**RESOURCE CONSENT SUB~~1920~~/47312 AND LUC19/47535**

**Granted under Sections 95A, 95B, 95D, 95E, 104, 104D, 108, and 220 of the Resource Management Act 1991.**

<b>Applicant:</b>	<b>Manor Property Limited</b>
<b>Location:</b>	<b>19 Egmont Road, New Plymouth</b>
<b>Legal Description:</b>	<b>Lot 2 DP 400849 (held in RT 401595)</b>
<b>Status:</b>	<b>The proposal a Non-Complying Activity under the Operative New Plymouth District Plan</b>
<b>Proposal:</b>	<b>Non-Complying Activity 2 Lot Residential Subdivision and Land-use consent for industrial activities on Lots 1 and 2</b>

**Figure 1:**

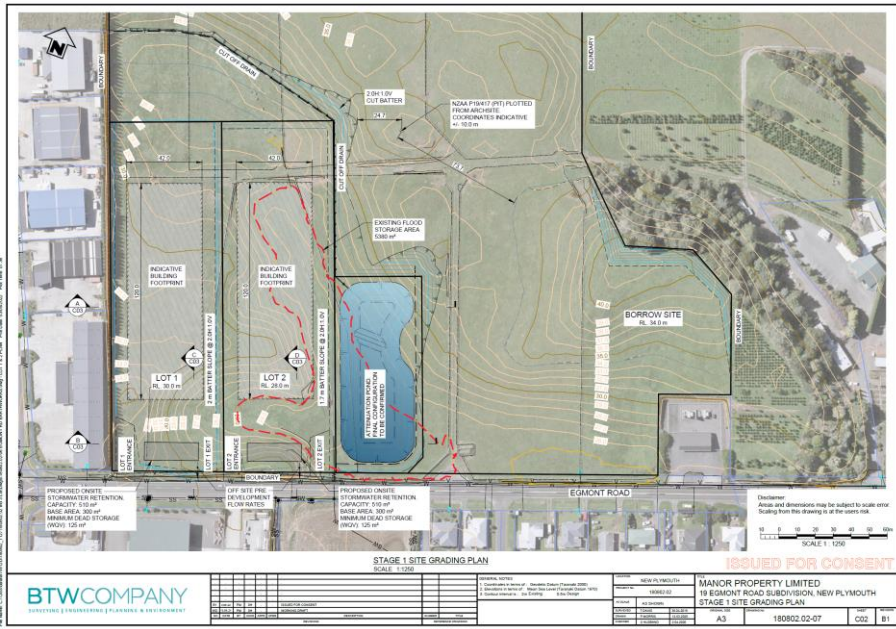
20. Earthworks shall be undertaken in general accordance with the plans:  
20.1 Stage 1 Site Grading Plan, Drawing No. 180802.02-07, Sheet C02, Revision B1;  
20.2 Stage 1 Sections, Drawing No. 180802.02-07, Sheet C03, Revision B1;  
and  
20.3 Stage 1 Earthworks Cut Fill Plan, Drawing No. 180802.02-07, Sheet C04, Revision B1;  
as shown in Figures 1-3 below.

**Commented [DM6]:** Updated the figures below per the drawings of the BTW stormwater memo dated 1st April 2022
